**DA2020/1761 Application for Sect.4.55 Amendment - Stormwater Discharge Outlet
287 Hudson Parade, Clareville
NBCE Job No 130101**

This is a submission for a Section 4.55 Amendment application, to DA2020/1761, on behalf of our client and property owner Ms Jill Morrison.

Photo 1: Approximate location of proposed outlet.

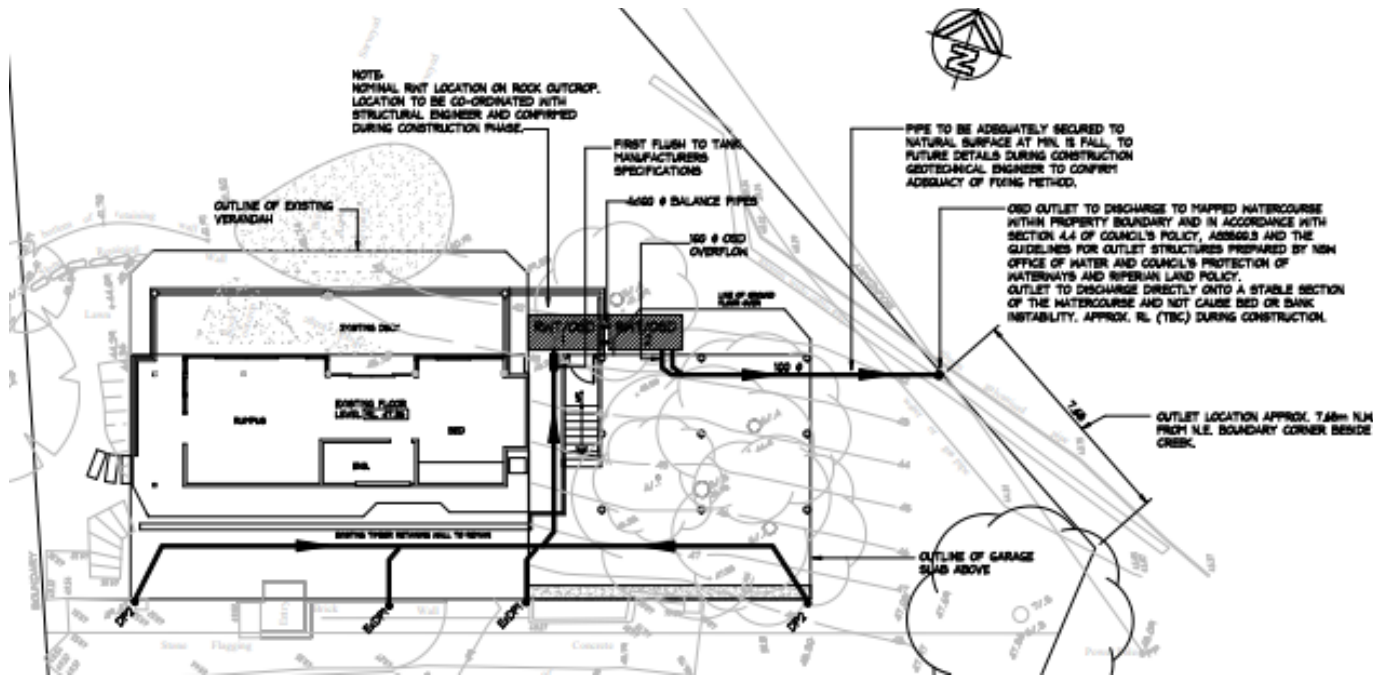
- The site inspection identified an appropriate location to discharge onto the creek bed extent directly from the property.
- The location is approximately 7.68m northwest from the northeastern boundary corner; Refer photo 1 . The outlet location and method of discharge to the watercourse is similar to existing outlets discharging from neighboring properties; Refer photo 2.
- As this proposed outlet to the creek is located within the property, an easement is not required.
- This is shown on NBCE Stormwater Discharge Outlet drawing 130101 – D102 – Rev D, included below for convenience.
